UNITED STATES PATENT AND TRADEMARK OFFICE

| APPLICATION NO. | FILING DATE | FIRST NAMED INVENTOR | ATTORNEY DOCKET NO. | CONFIRMATION NO. |
|-----------------|-------------|----------------------|---------------------|------------------|
| 10/763,456 | 01/23/2004 | Steven Frisch | AP-225 | 6754 |

Office Action Summary

DETAILED ACTION

O. & W. THUM.
BOOK OF STICKY FLY PAPER.

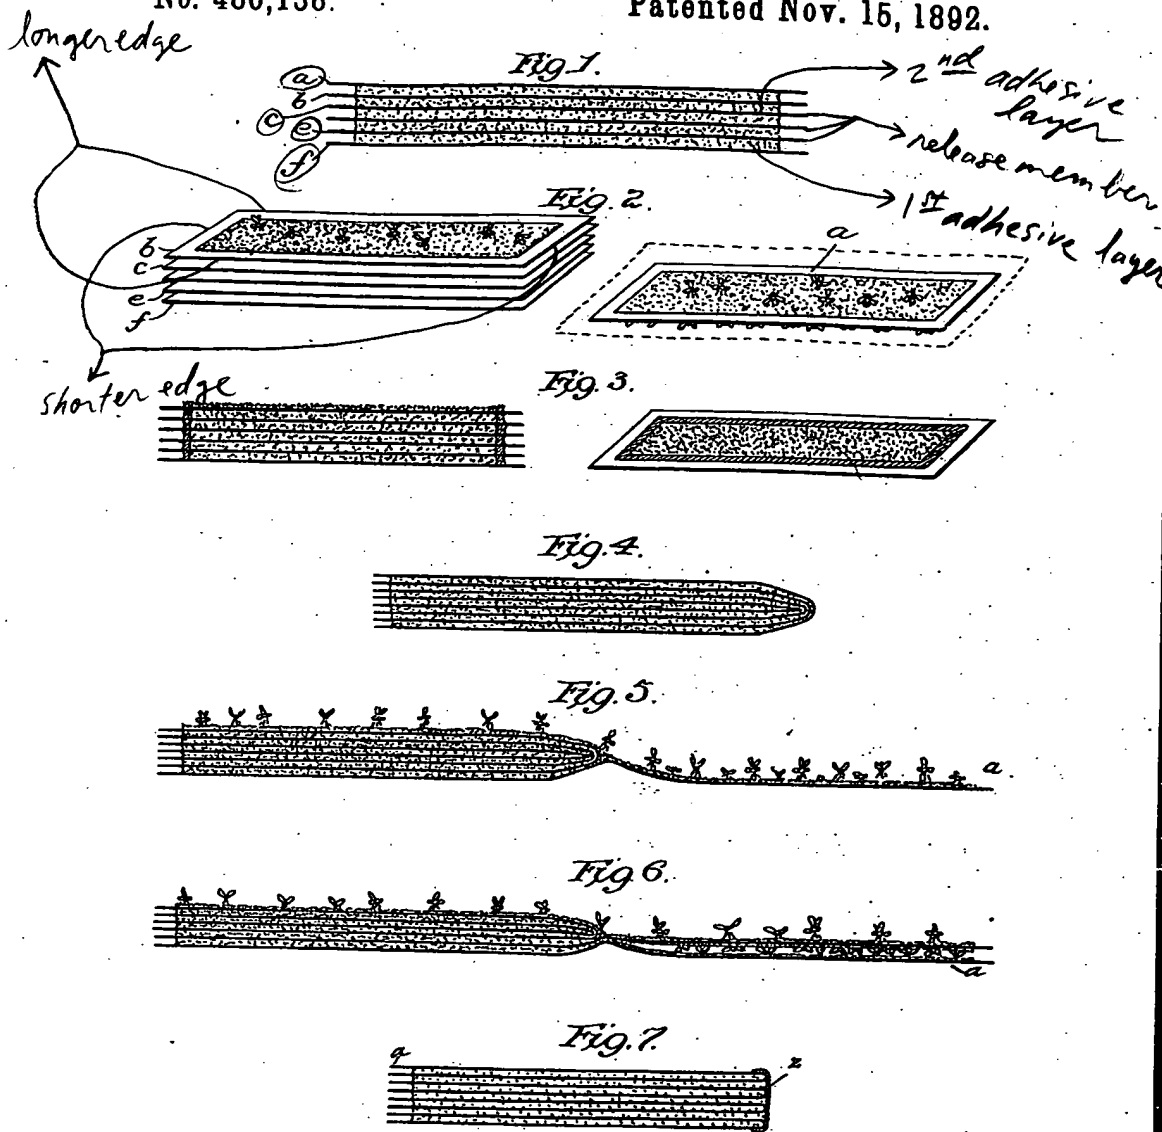
10. Claims 1-4, 7, 13, and 15 are rejected under 35 U.S.C. 102(b) as being anticipated by Thum (US 486,138) (Please see a more detail Figures 1 and 2 of Thum attached with the Office Action for further explanation for claims 1-4, 7, 13, and 15).

For claim 1, Thum discloses a glue board and packaging assembly comprising: a first substrate (f); a first adhesive layer deposited on said first substrate; a release member with said release member overlying said first adhesive layer; a second

substrate (a); a second adhesive layer with said second adhesive layer in contact with said release member.

For claim 3, Thum discloses said release member comprises a thin flexible member, a first release coating (e) deposited on said first surface, and a second release coating (c) deposited on said second surface.
